SUBJECT: Calvert Cliffs Nuclear Power Plant
Independent Spent Fuel Storage Installation; Docket No. 72-8
Response to Second Request for Additional Information for Renewal Application
to Special Nuclear Materials License No. 2505 for the Calvert Cliffs Site Specific
Independent Spent Fuel Storage Installation

**SECOND REQUEST FOR ADDITIONAL INFORMATION FOR
RENEWAL APPLICATION**

Figure 1 – Heat Loads of Currently Loaded DSCs During the Initial and Extended ISFSI License Period

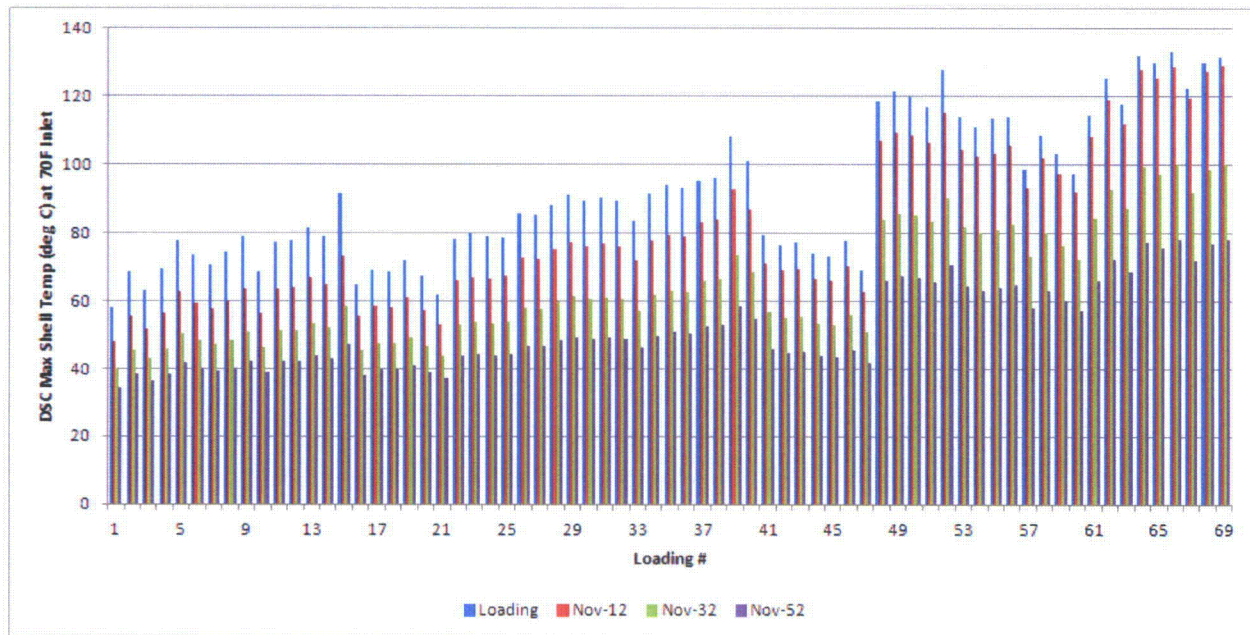
Provide justification that no welds or cask surfaces currently have or will have a temperature of $\leq 85^{\circ}\text{C}$ over the next 40 years, at temperatures bounded by normal conditions of storage. If the surface temperature decreases below 85°C at conditions in which the stainless steel components are susceptible to stress corrosion cracking, justify why the planned inspections are adequate to detect potential degradation as a result of stress corrosion cracking.

Figure 1 below provides the initial and estimated heat loadings of all currently loaded DSCs during the current and extended ISFSI license period. The heat load by assembly in each canister was adjusted from the time of loading for decay to each of the future dates shown using the equation given in Reference 2 (page 132). To provide some sense of when these DSCs will fall below the 85°C temperature threshold discussed in RAI O-6, an estimate of DSC surface temperature was developed. The best information available currently comes from design basis calculations which determine the maximum DSC shell surface temperature (DSC top center) for comparison against design limits. Those calculations give a maximum shell surface temperature of 144°C for a 21.12 kW NUHOMS-32P DSC (Reference 3, page 11) and 121°C for a 15.84 kW NUHOMS-24P DSC (Reference 4, Table 8.1-12), when stored inside an HSM with 70°F (21°C) inlet air temperature. These two maximum temperature points were trended with a nominal 0 kW canister with a 21°C surface temperature. The resulting trend ($T(h) = -0.0947 h^2 + 7.8125 h + 21.111$; where h is DSC heat load in kW) was then used to develop the estimate of the maximum surface temperatures of each DSC by heat load shown in Figure 2 (lower temperatures would be expected at the bottom and ends of the DSC). The results suggest that many of the earliest canisters loaded have spent most of their time in storage below 85°C .
